Product Change Notification: P-19-017242

Signal Double Lock SDL 2.5mm 4P double lock plate(TPA)

Revise 917700-1 and 917700-2 to add new material.

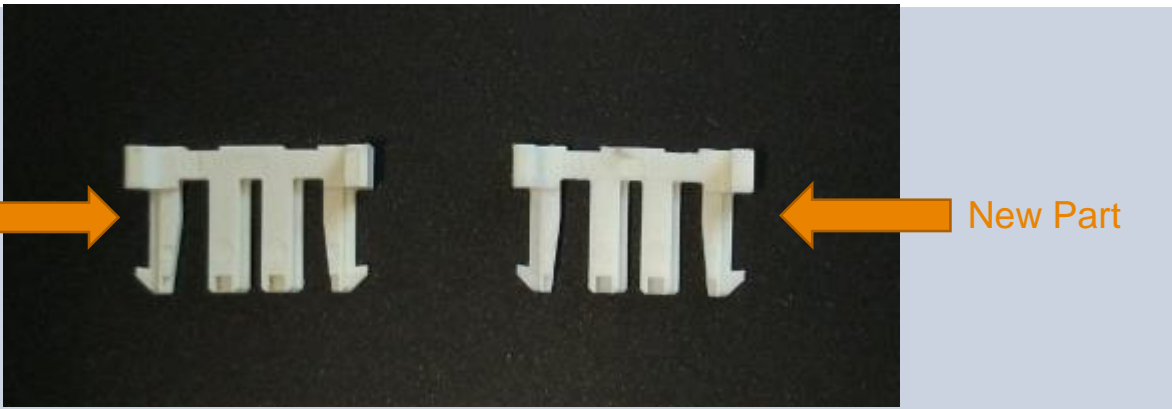
PCN Reason for Change:

Adding a second resin to accommodate market constraints. There are no performance changes, Test report and material change detail can be found in the attachment of this PCN, Material certification is available upon request to your local TE Connectivity Sales Engineer.
